Oyster Creek Nuclear Generating Station
Renewed Facility Operating License No. DPR-16
NRC Docket No. 50-219

Subject: Response to Request for Additional Information - End of Interval Relief Requests Associated with the Fourth 10-Year Inservice Inspection (ISI) Interval

Response to Request for Additional Information

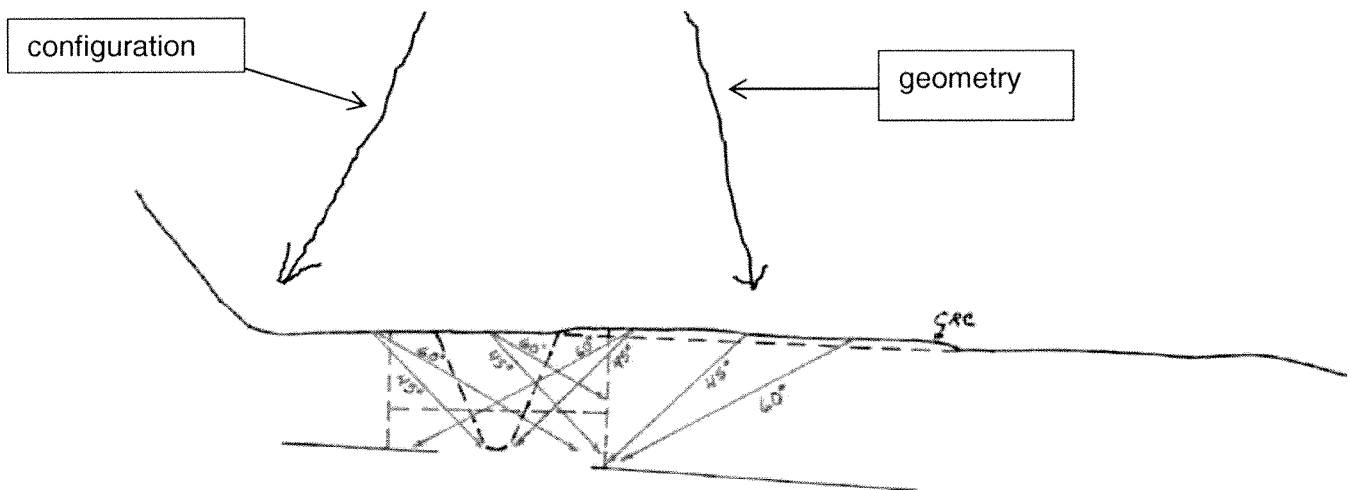
2.3.1 The licensee has provided only general information regarding the impracticality of obtaining ASME Code-required volumetric examinations for Category B-F, Item B5.10 welds. The statements "OD [outside diameter] safe end configuration," and "Nozzle OD configuration," are inadequate to explain the bases for not obtaining the ASME Code required examination volumes. Please submit detailed and specific information to support the bases for limited examination coverage for each weld in ASME Code, Category B-F, and therefore, demonstrate impracticality. Include detailed descriptions (written and/or sketches, as necessary) of the interferences to applied nondestructive examination techniques, if not already provided.

Weld NR02 5-567: Nozzle configuration and CRC geometry limited the scanning. Surface preparation of this weld was limited due to its location close to the bioshield and the adjacent main steam line. See the sketch below for the nozzle configuration and CRC geometry.
